SUQUAMISH REGIONAL STORMWATER TREATMENT FACILITY

ADDENDUM # 2

Questions & Answers – March 13, 2025 Attachment to ADDENDUM # 2

**SUQUAMISH REGIONAL
STORMWATER TREATMENT
FACILITY PROJECT**
WQ TREATMENT VAULT DETAILS - 1

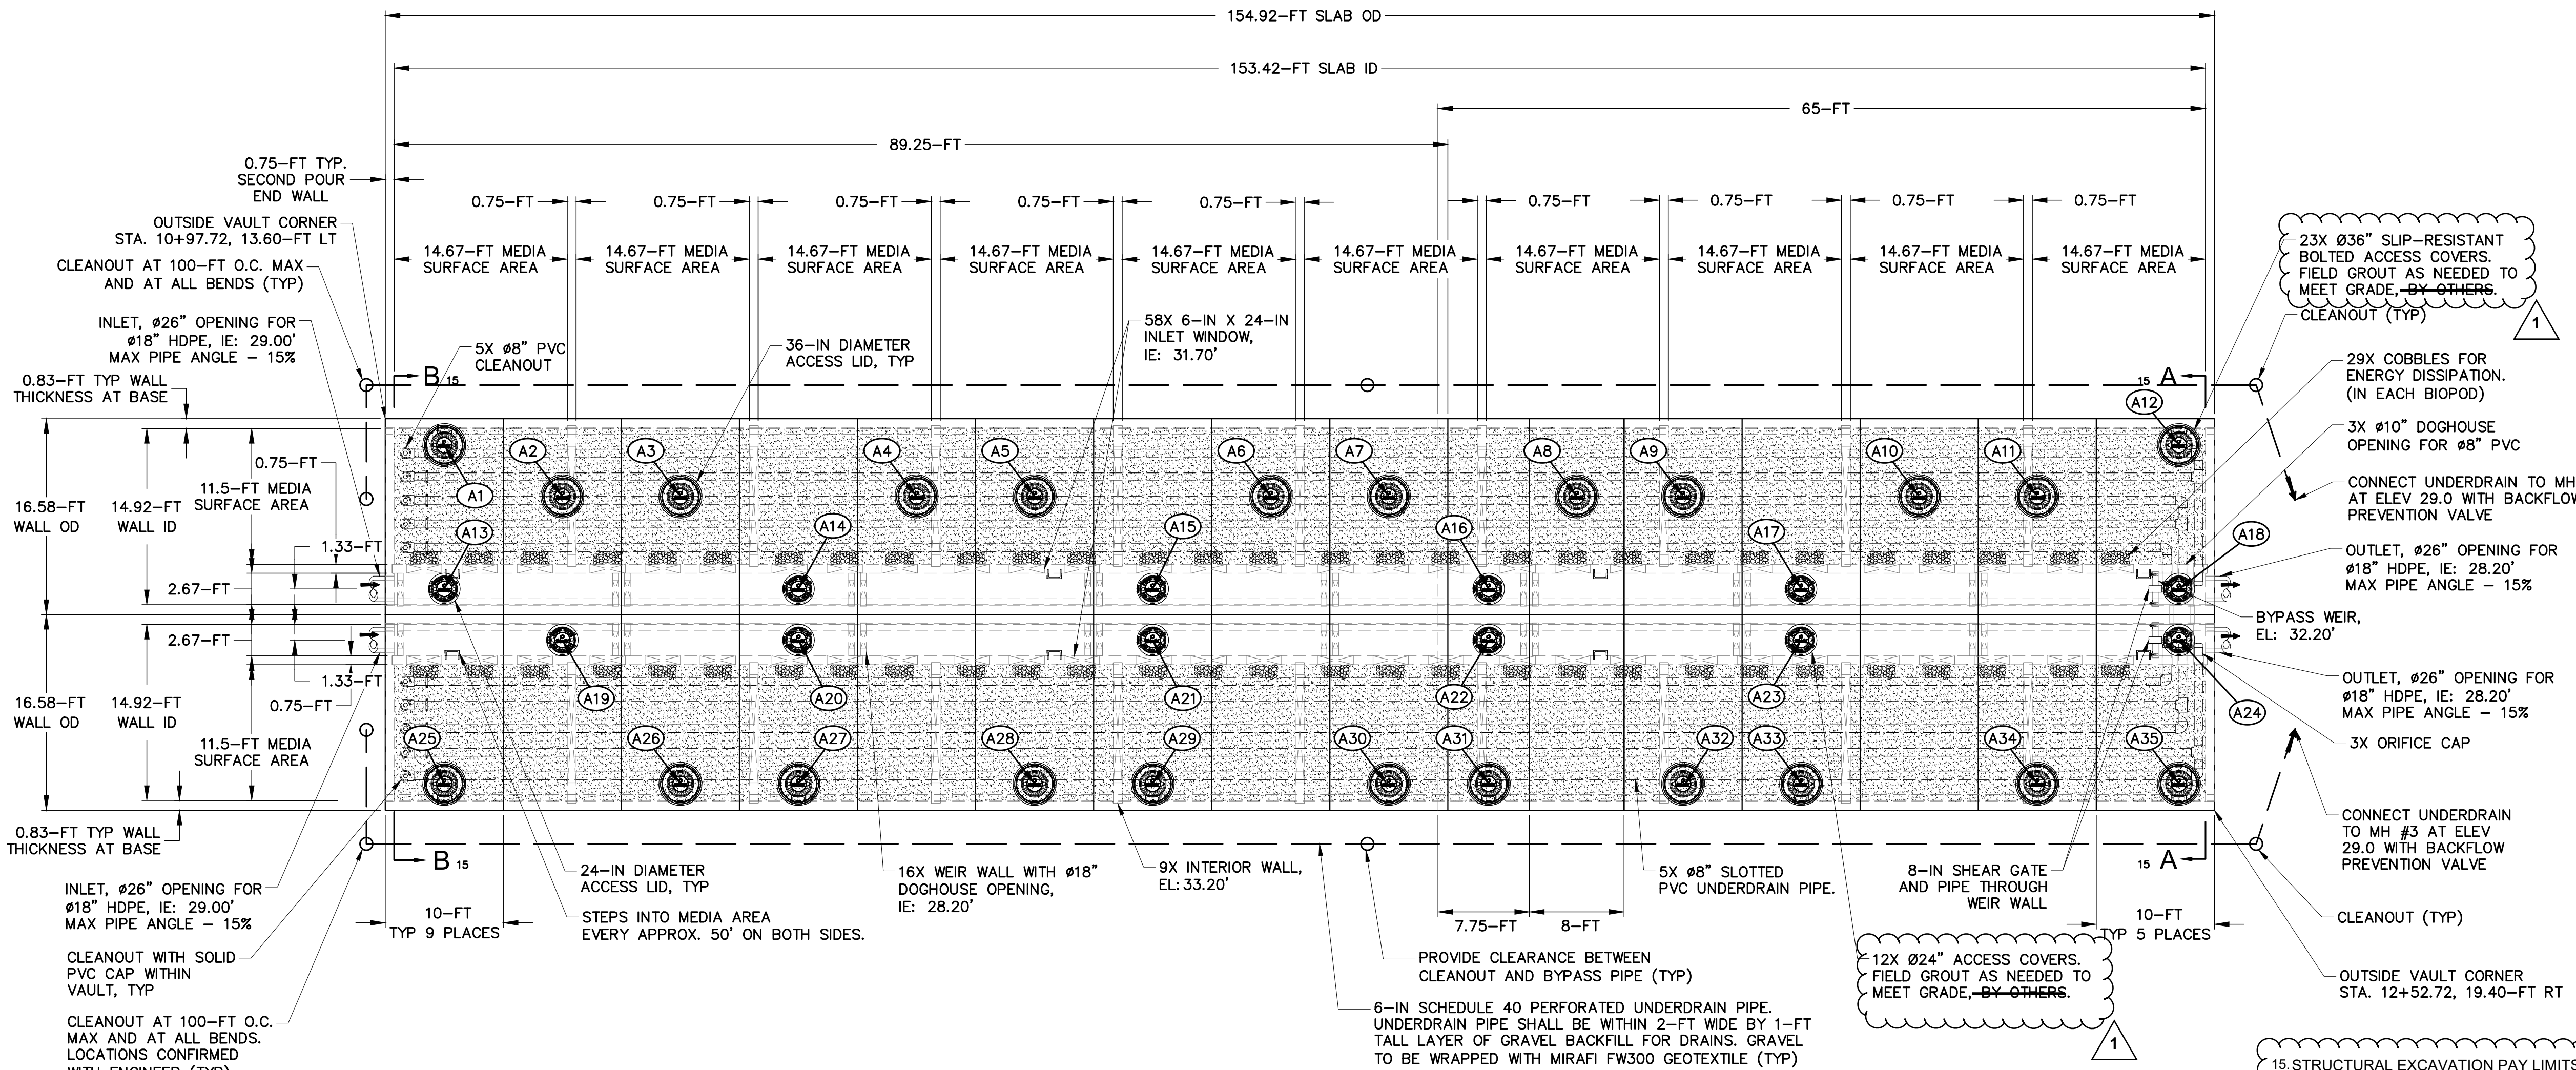
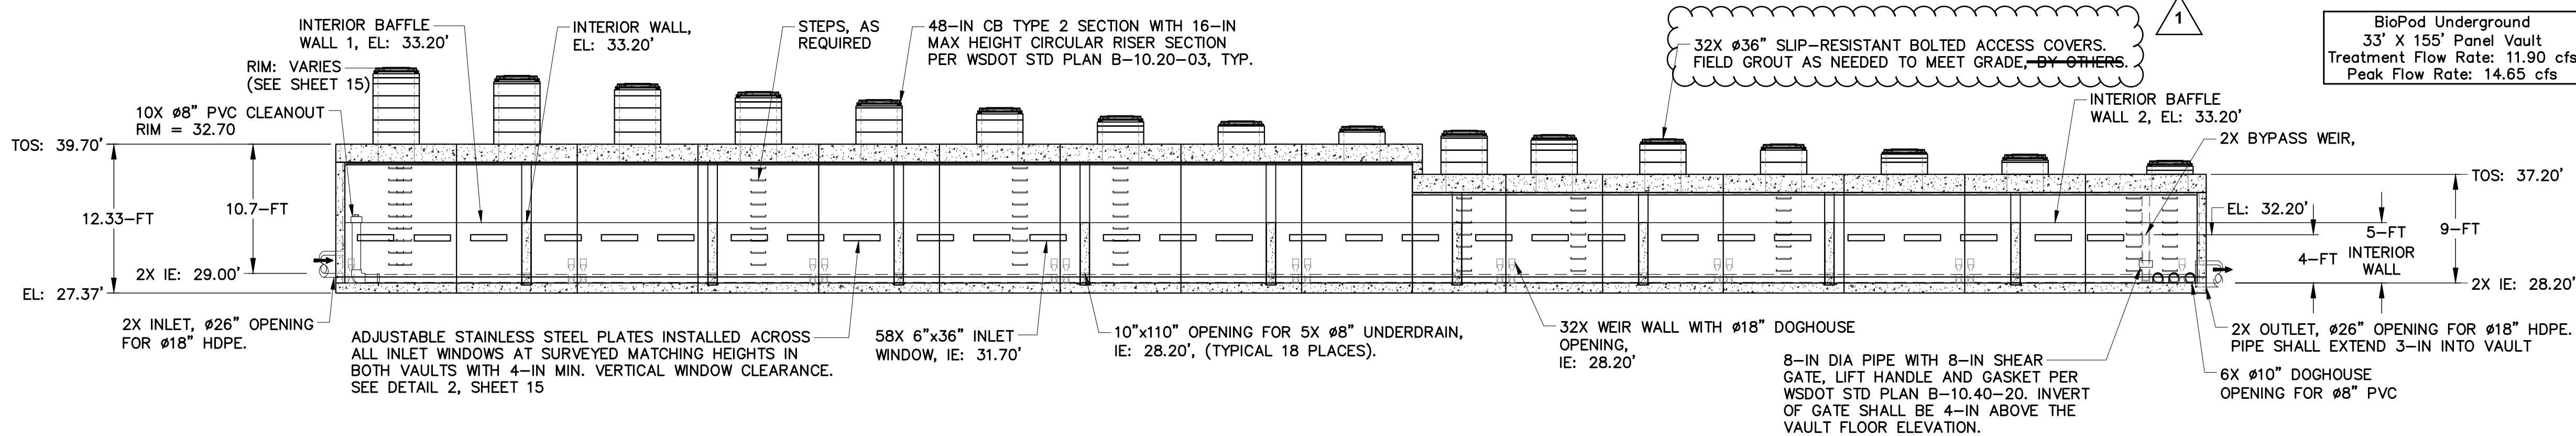
- A. **Plan Sheet Number 14, WQ TREATMENT VAULT DETAILS – 1**, is amended per Delta Revision #1, dated 3/11/25, for Construction Note Updates.

NO.	DATE	REVISION
1	3/11/25	CONSTRUCTION NOTE UPDATES
